SAN FRANCISCO PLANNING DEPARTMENT

Memo to the Planning Commission

Case No.: 2010.0515CWP
Project Name: Potrero HOPE SF Block B
Zoning: RM-2 (Residential, Mixed, Moderate Density)
Potrero HOPE SF SUD
40/65-X Height and Bulk
Block/Lot: 4167/ 004 and 004A; 4220A/ 001; 4222A/, 001; 4285B/ 001, 4223/ 001;
4287/076 and 007
Project Sponsor: Bridge – Potrero Community Associates, LLC
Staff Contact: Mat Snyder – (415) 575-6891
mathew.snyder@sfgov.org
Recommendation: **Approval**

CURRENT PROPOSAL

ZONING HEIGHT DIAGRAM - FIGURE 5.1

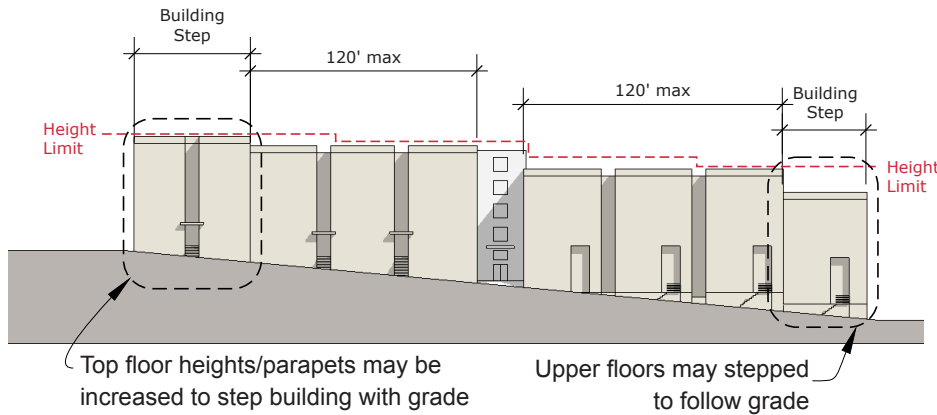
The requested amendments would do the following: (1) revise Zoning Height Diagram – Figure 5.1 by redesignating Block B from a 40-foot height limit to a 50-foot height limit with provision allowing buildings to be taller than 50-feet (to a maximum of 65-feet) in limited locations on the block; (2) revise Section 5.1.1 “Building Heights” by adding Standard No. 6, which enumerates where and under what conditions heights could be allowed to be taller than 50-feet; and (3) updating the non-regulatory narrative description of Block B in Section 5.2.1. Currently, this narrative describes a potential scenario of constructing about eight small sized apartment buildings whereas the current proposal is to construct two larger-scale L-shaped buildings.

WHEREAS, on February 1, 2020, Bridge-Potrero Community Associates, LLC (herein “Project Sponsor”) requested an amendment to Figure 5.1 “Zoning Height Diagram” and DSG Standard 5.1.1 of the DSG to allow a height increase from 40-feet to 50-feet for the entirety of Block B, and to allow heights to increase to 65-feet on limited portions of the site described therein.

NOW THEREFORE BE IT RESOLVED, that the Planning Commission approves the requested amendment to Figure 5.1, Section 5.1.1, and Section 5.2.1 of the Potrero HOPE SF DSG for the following reasons:

6. Additional height greater than the underlying height limit indicated in Figure 5.1 are permitted on Block B as long as the following conditions are met:

- a. Notwithstanding height exceptions otherwise allowed in the Planning Code and the Potrero HOPE SF Design Controls and Guidelines, in no case shall the height of any portion of any building exceed 65-feet.
